Engineering Change Order (ECO)

ECO #: ECO-70041-003

Title: Two resistor value changes for BOM

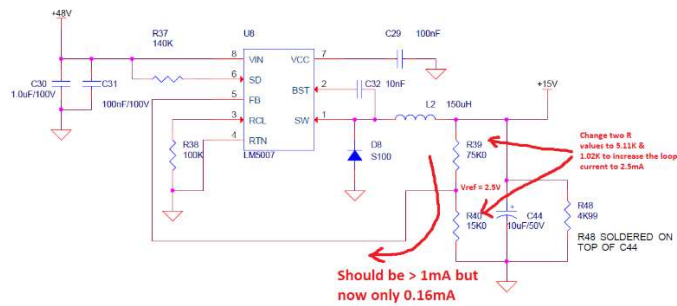
The MSS motor controller PCB electronics on this PCB includes a 48V to 15V DC-DC converter circuitry. Recent failure analysis discovered an error in two resistors in a related voltage divider network. This ECO addresses this issue by changing the two resistor values to rectify the above said error.

The MSS motor controller PCB electronics on this PCB includes a 48V to 15V DC-DC converter circuitry. Recent failure analysis discovered an error in two resistors in a related voltage divider network. As shown in the diagram below the loop current in the feedback circuitry does not meet the min required current of 1mA. As a result, the motor controller behavior could be erratic or intermittent. The new values of two resistors R39 (5.11K) and R40 (1.02K) will increase the loop current to 2.5mA meeting the required minimum current of 1mA.

Part Number	Notes	Removed	Added	New	Modified
R39	Resistor value changed from 75K to 5.11K ohm	☐	☐	☐	☒
R40	Resistor values changed from 15K to 1.02K ohm	☐	☐	☐	☒
